From: Olvera,Brandon
Sent: Thursday, October 9, 2025 8:53 AM
To: Greg Johnson
Cc: Keith Eismann; Hendry,Clint
Subject: RE: 2425 W. AMMANN RD - JDK ASSOCIATES #118182

Permit Number: 118182
Issued This Date: 03/20/2025
This permit is hereby given to: JDK ASSOCIATES, INC.

2425 W AMMANN RD
BULVERDE, TX 78163

Planning Materials & Site Evaluation as Required Completed By GREG W. JOHNSON, P.E.System Description PROPRIETARY; AEROBIC TREATMENT AND SURFACE IRRIGATION

OWNER:	JDK ASSOCIATES, INC.	DRAWN BY:	GWJ
STREET ADDRESS:	2425 W. AMMANN ROAD		
LEGAL DESC:	EDWARD VELASCO SURVEY No. 223, A-647	ACREAGE:	19.849
PREPARED BY:	GREG W. JOHNSON, P.E. F#002585	SCALE:	N.T.S.
		DATE:	11/01/2024
		REVISED:	10/06/2025

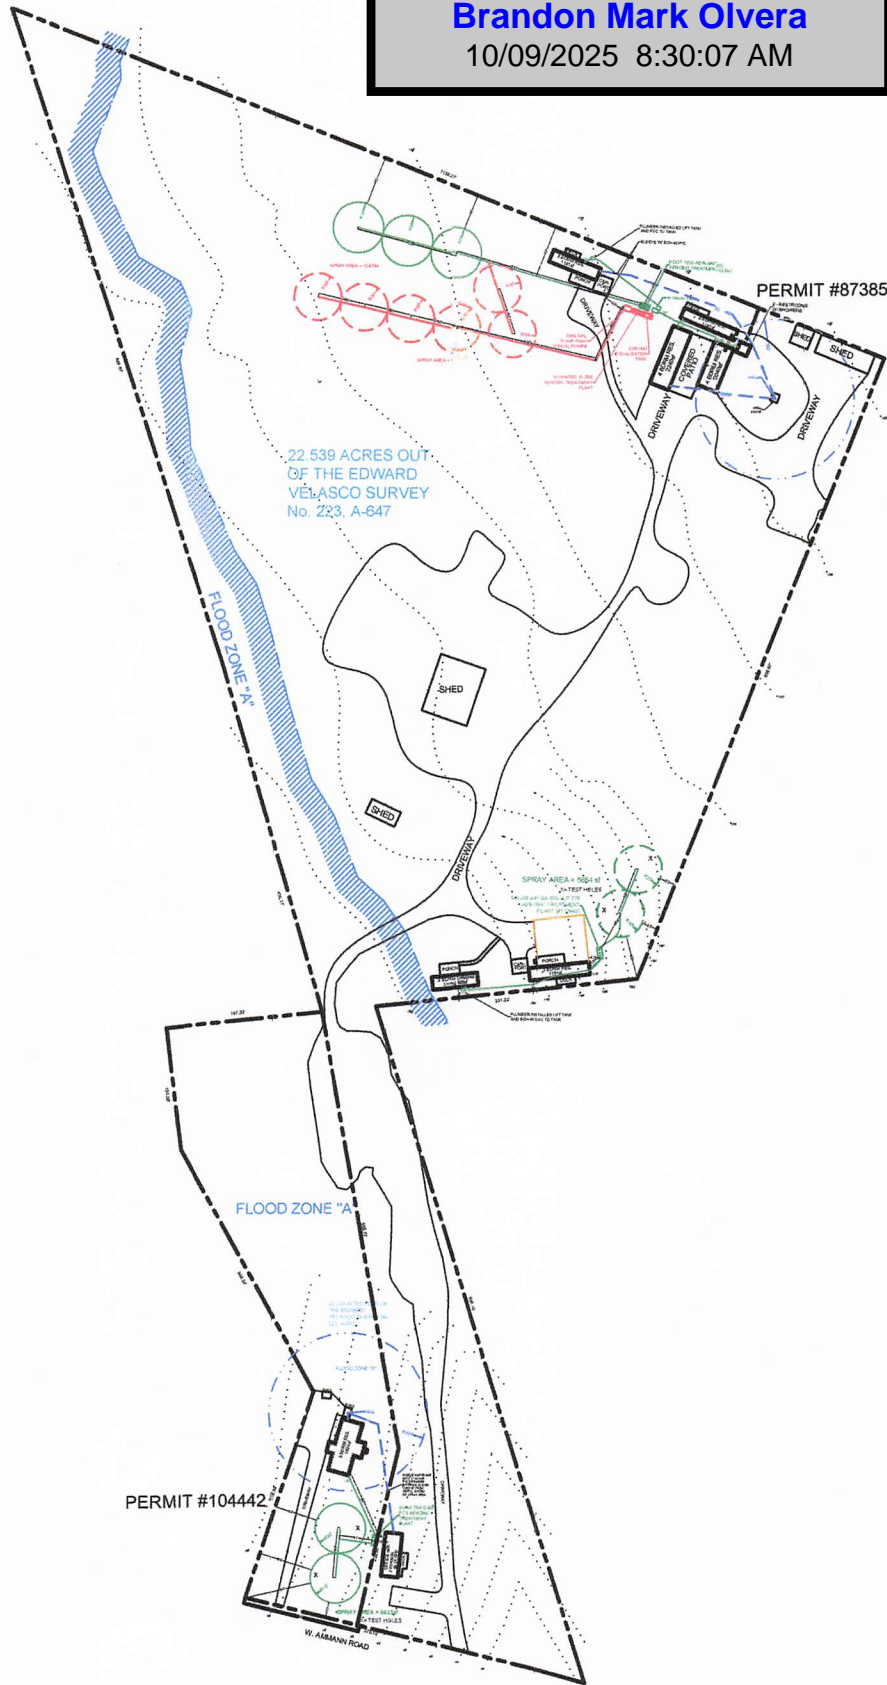
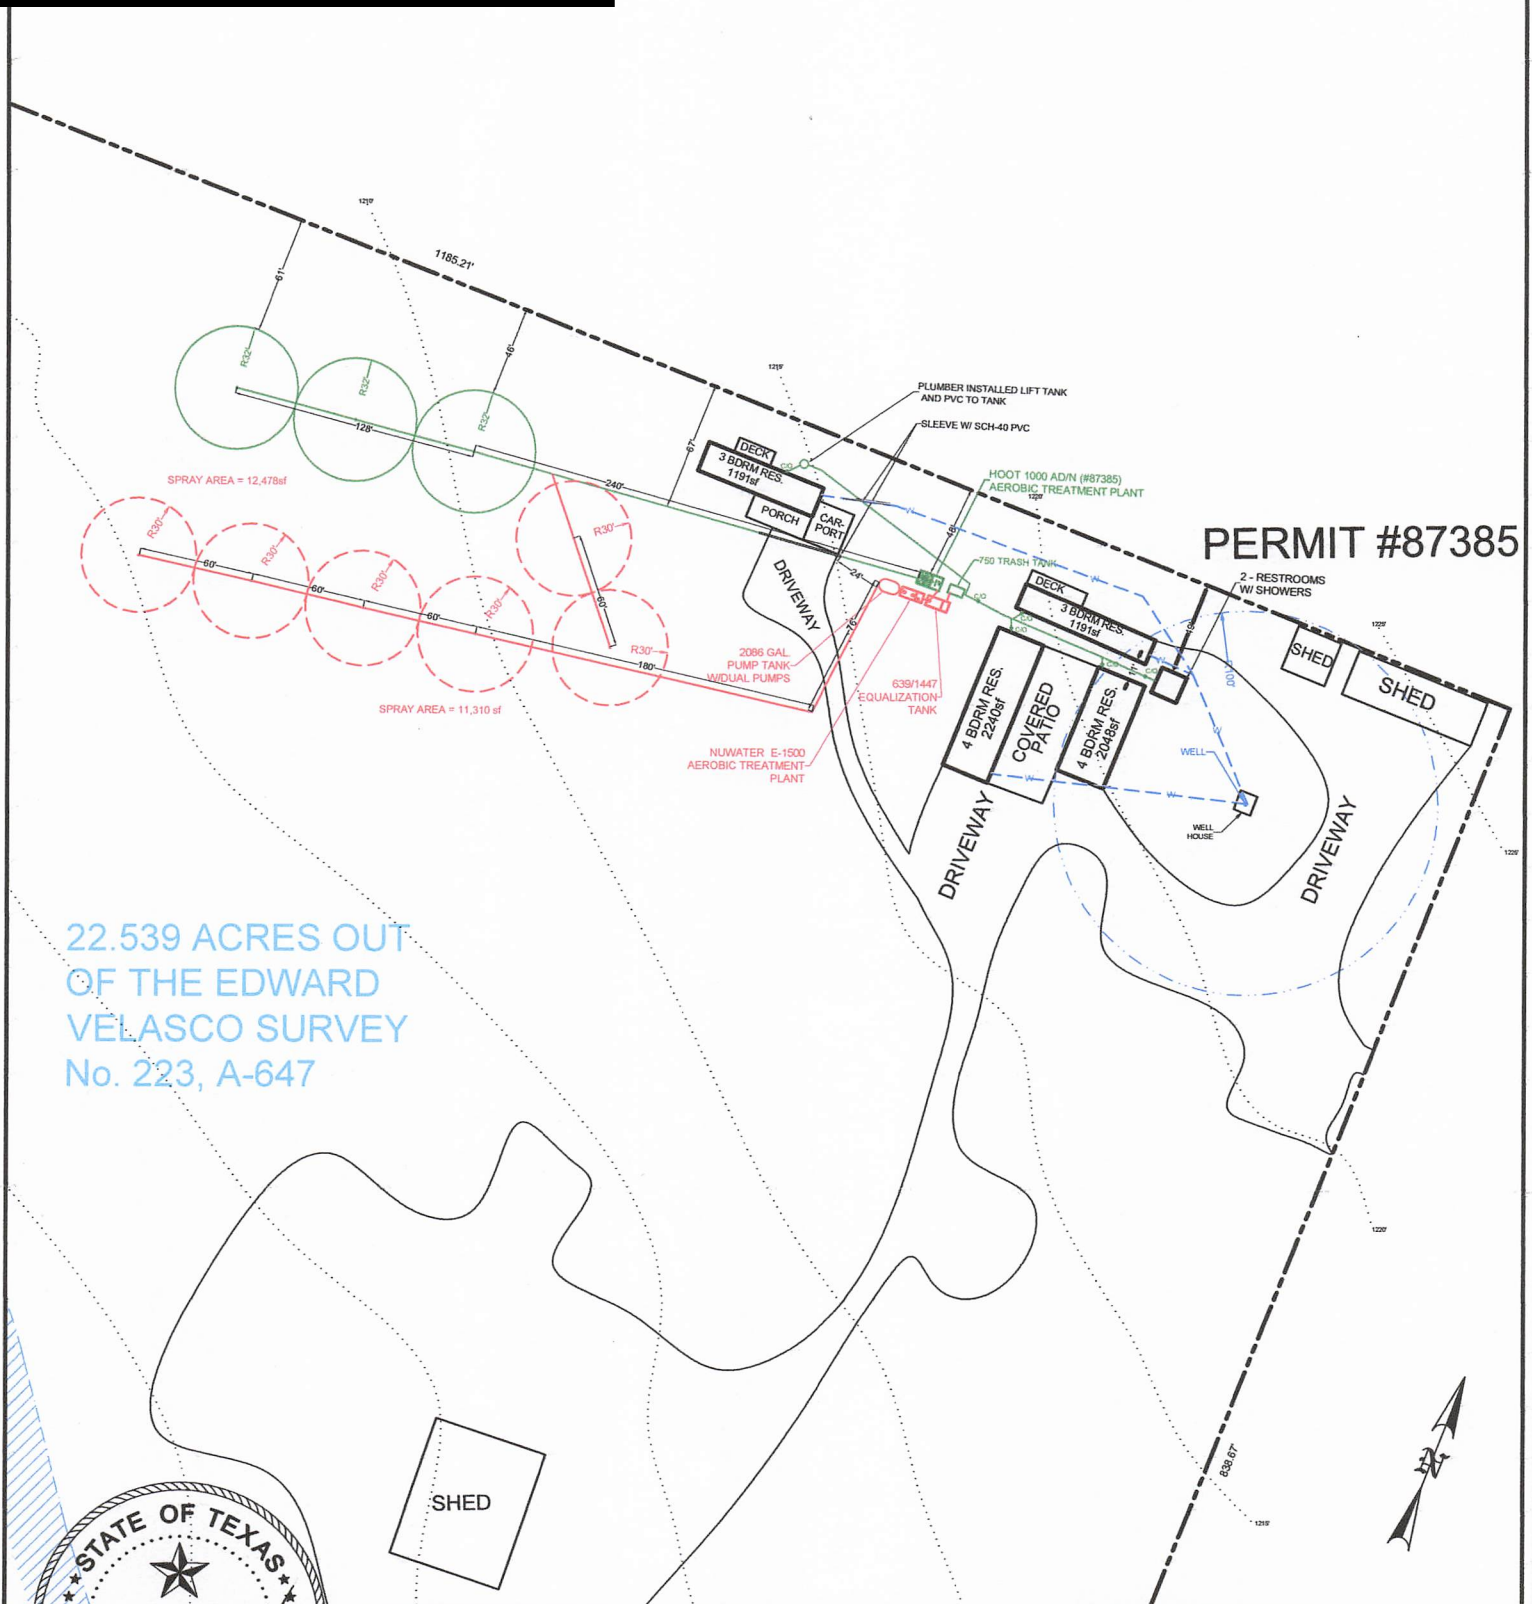
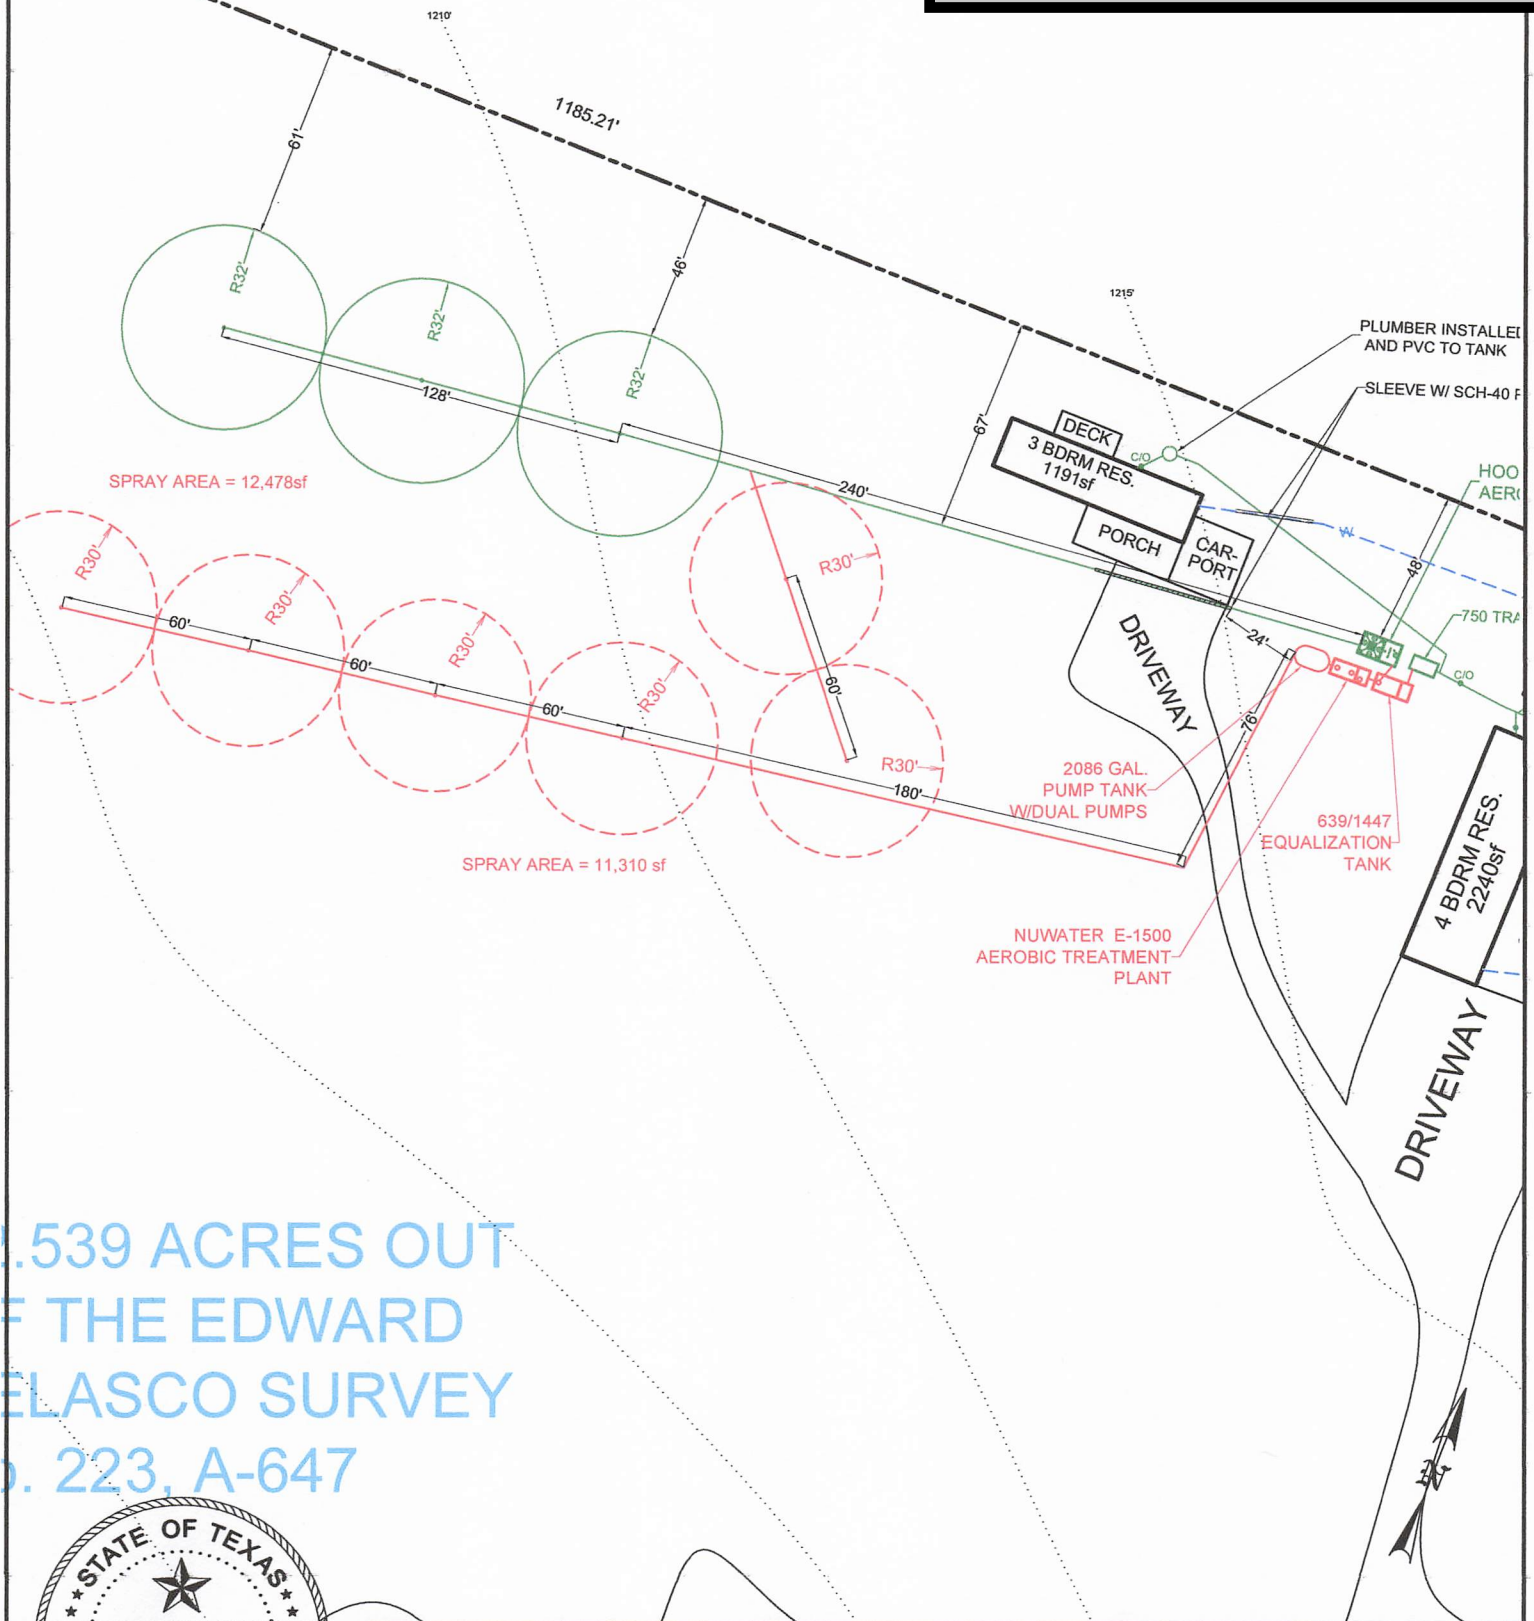
The combined absorption area for the Hoot system (15,306 sq.ft.) and the NuWater system (11,310 sq.ft.) totals 26,616 sq.ft. Since you're currently only claiming 23,788 sq.ft., you may want to consider claiming the full 26,616 sq.ft.

REVISED SPRAY.
THX,
GREG

OWNER:	JDK ASSOCIATES, INC.	DRAWN BY:	GWJ
STREET ADDRESS:	2425 W. AMMANN ROAD		
LEGAL DESC:	EDWARD VELASCO SURVEY No. 223, A-647	ACREAGE:	22.539
PREPARED BY:	GREG W. JOHNSON, P.E. F#002585	SCALE:	N.T.S.
		DATE:	11/01/2024
		REVISED:

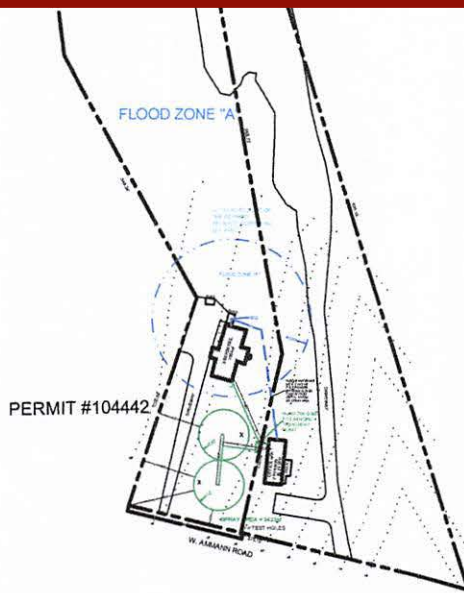
- ✓ Application Page 1:
 - a. State the number of bedrooms for each mobile.
 - b. State the number of restrooms
- 2. Site plan acreage does not match the acreage stated in the legal description.
- ✗ It appears that permit 104442 is shared by 2 properties with different owners
 - a. OSSFs for non-single families cannot cross property boundaries.
- ✓ Submit a cross section of all the tanks.
- 5. Revise accordingly and resubmit.

1. Revised application showing bedrooms and restrooms for each mobile home.
- 2 & 3. Acreage is 19.849 acres, but the owner is reacquiring the lot for Permit #104442 next month.
4. Attached are additional cross-sections of the tanks.
